INSPECTION REPORT
Sedimentation Structure
J3-B
Black Mesa Mine
Navajo County, Arizona
for
PEABODY COAL COMPANY

Dames & Moore
10139-011-22

EXISTING
MAXIMUM CROSS-SECTION
A-A'
J3-B

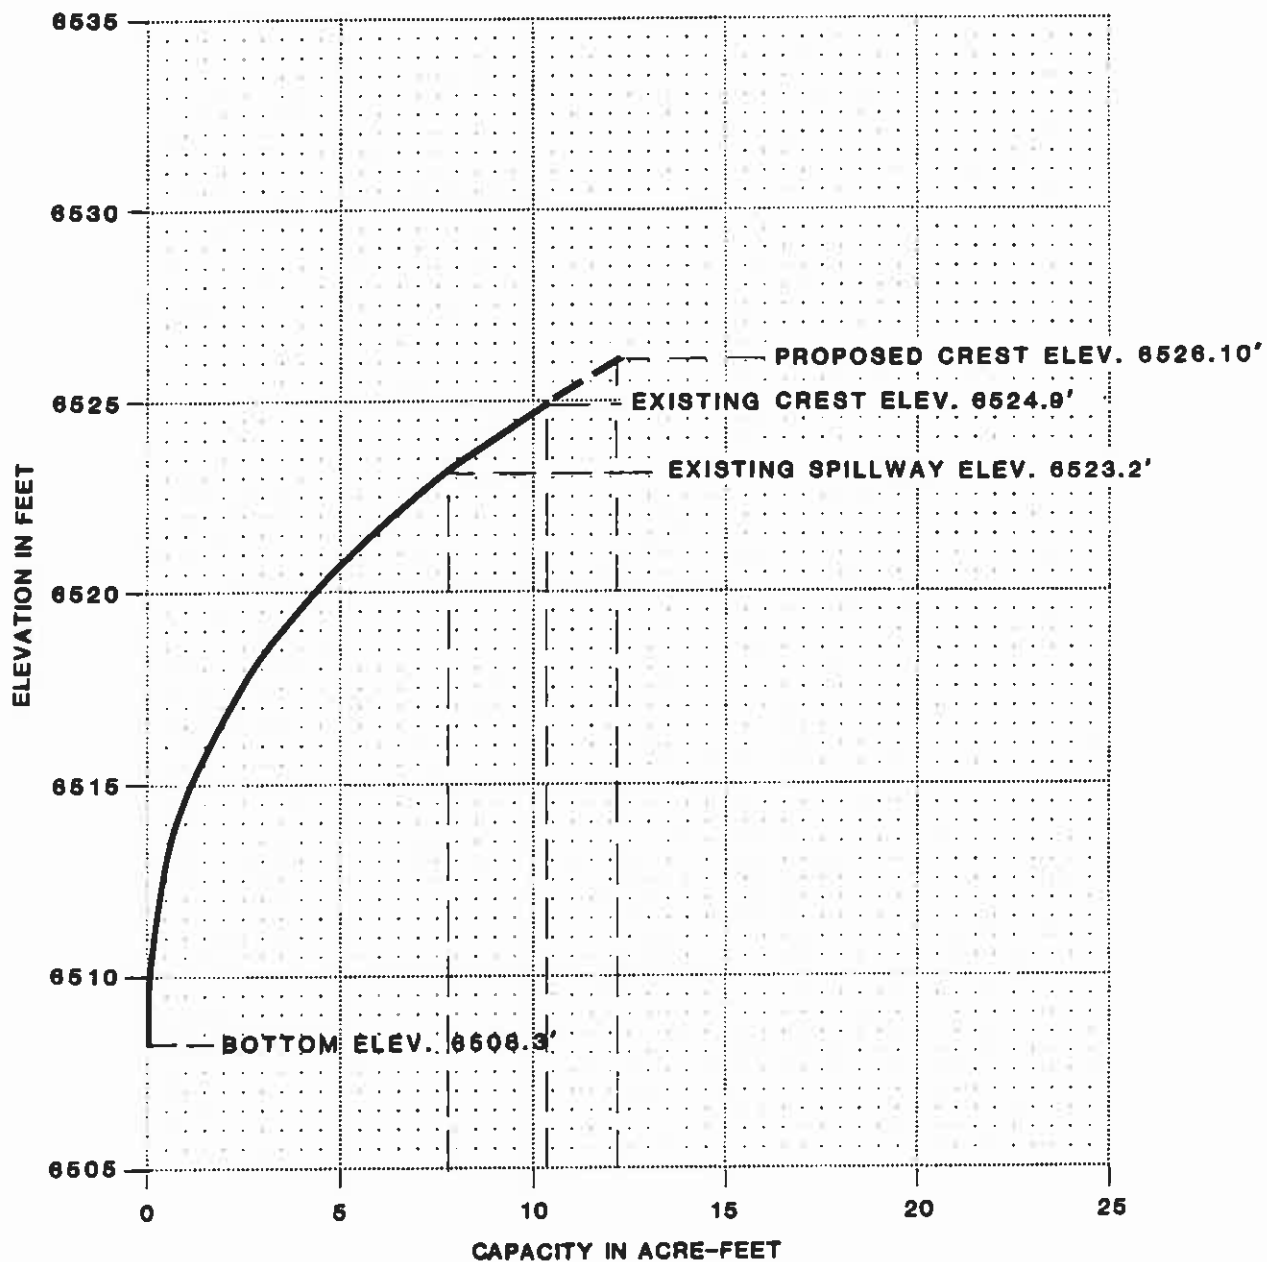
A cross-section of the embankment is shown on Plate 2, Existing Maximum Cross Section J3-B, A-A'.

The storage capacity of Structure J3-B is adequate but the spillway capacity is inadequate. The structure does not have an adequate outflow channel. The embankment crest should be raised to elevation 6526.10 feet. A trapezoidal outflow channel and a stilling basin should be constructed along the alignment shown in Plate 1. The channel and stilling basin profile is shown in Plate 4 and the required dimensions are shown in Plate 5 and Plate 6. The spillway, outflow channel and stilling basin should be protected against erosion using geotextile and riprap as shown in Plate 5.

**SPILLWAY AND
OUTFLOW CHANNEL
CROSS SECTION
J3-B**

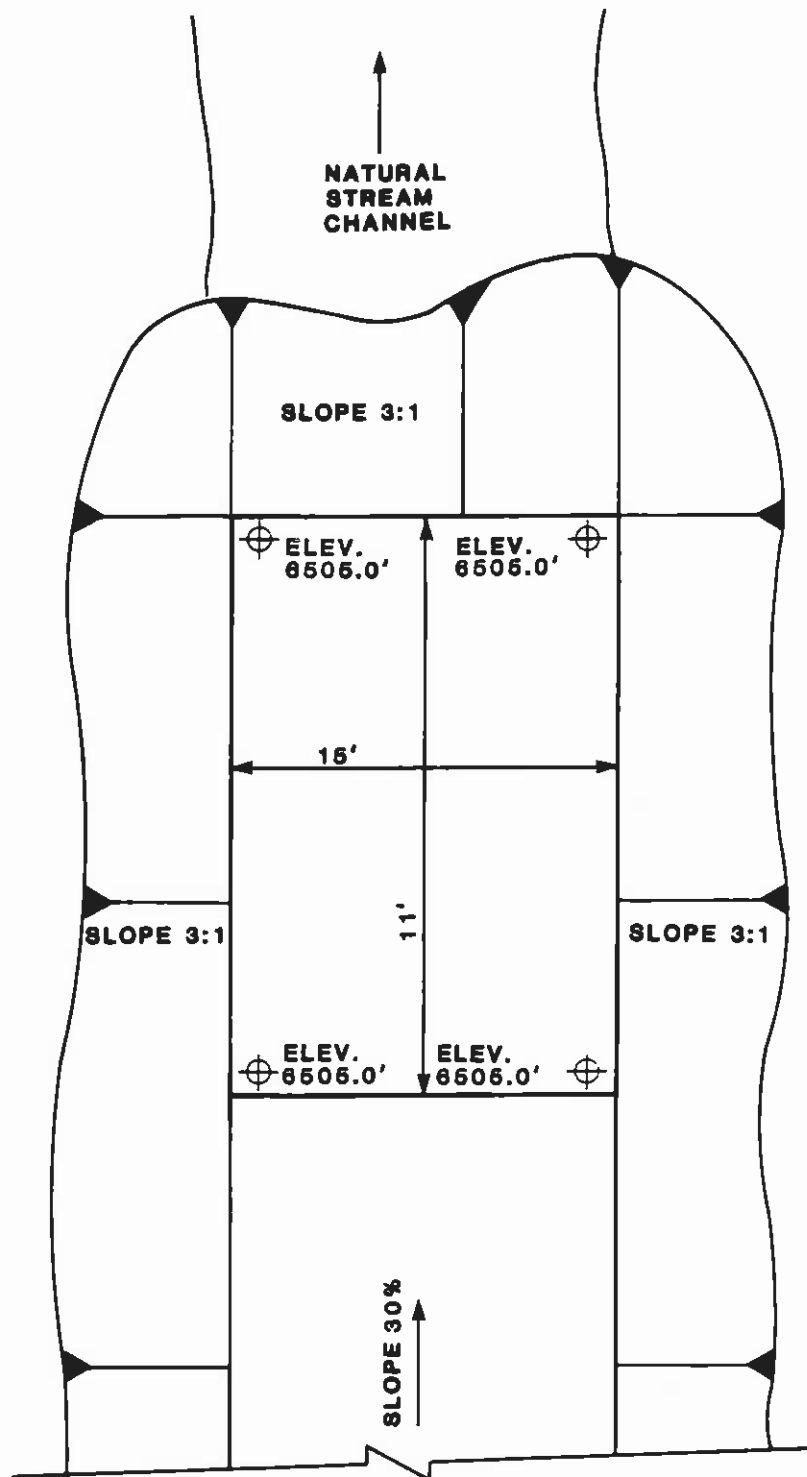
There is presently no erosion protection within the channel.

There is presently no erosion protection within the channel.

MINIMUM HEIGHT OF RIPRAP
ALONG SIDEWALLS ABOVE
THE BASIN FLOOR = 3.2'

MINIMUM DEPTH OF BASIN FLOOR
BELOW NATURAL STREAMBED = 1.5'
